Noise Symptom - Buzzing Noises from the Front Door Panel Area: Reworking Door Panel (SY 211/21)

Model Line: **Cayenne (9YA/9YB)**

Model Year: **As of 2018 up to 2022**

Concerns: **Front door panel**

Affixing felt strips

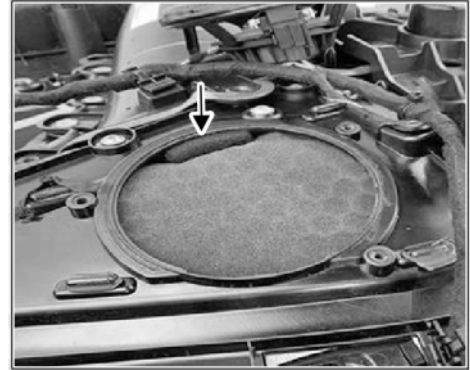
Cause: Due to a lack of connection in the middle area of the loudspeaker cover and the resulting misalignment, it is possible that the loudspeaker cover is touching the armrest when the loudspeaker vibrates (e.g. when making calls) and this may result in irritating noises.

- 2 Affix two felt strips (35 x 22 x 5 mm/ 1.38 x 0.87 x 0.2 in), one on top of the other, between the door panel and loudspeaker grille. ⇒ *Affixing felt strips*
- 3 Reinstall loudspeaker to front door panel.
For instructions, see:
⇒ *Workshop Manual '914119 Removing and installing front loudspeakers (door)'*
